STAFF REPORT
COMMUNITY DEVELOPMENT DEPARTMENT

HEARING DATE: 6/28/2022
JOSTO: Mayor & City Council
FROM: Alan Tiefenbach, Associate Planner
208-498-0573
SUBJECT: SHP-2022-0007
Ferguson Townhomes Short Plat
LOCATION: 1335 NE 4th Street

B. Proposed Short Plat (date: 3/11/2022)

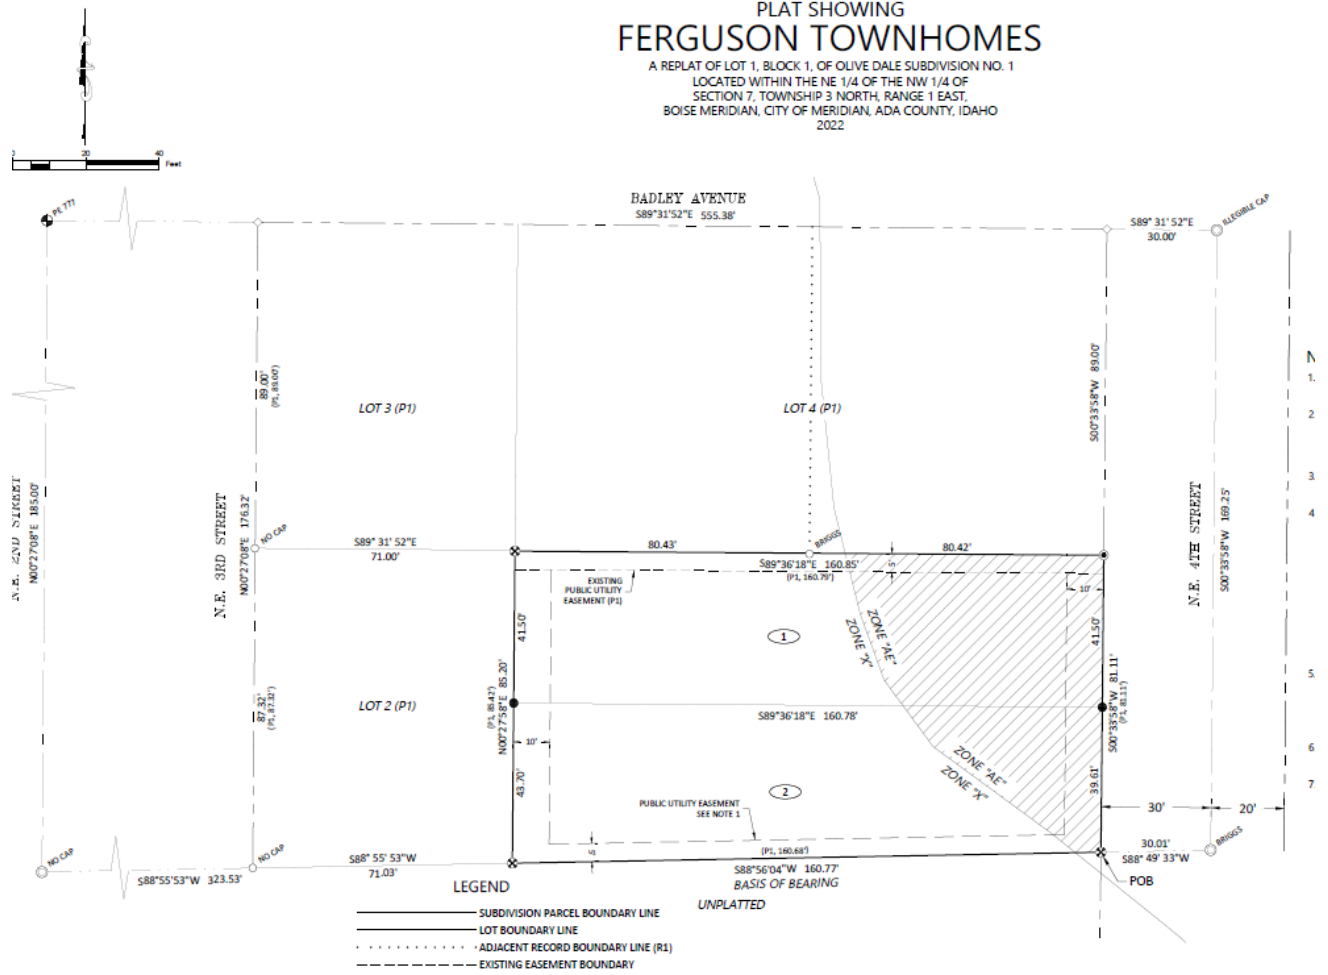
Staff has reviewed the requested short plat proposal. If the plat is revised to adjust the internal lot line between Lots 1 and 2 so both lots meet the minimum 40 ft. frontage requirement in the R-8 zoning district, the proposal would meet the criteria for approval per UDC 11-6B-5.

1. The short plat prepared by Aaron P Rush PLS, dated 3/11/2022, included in Section VI.B is approved with the following revision:
 - a) The applicant shall reconfigure the internal lot between Lots 1 & 2 to meet the minimum 40 ft. lot frontage requirement of the R-8 zoning district.

- b) The internal lot line between Lots 1 & 2 shall be graphically depicted as a zero-lot line.
2. The applicant shall obtain a floodplain permit in conformance with UDC 11-6B-5 prior to building permit.
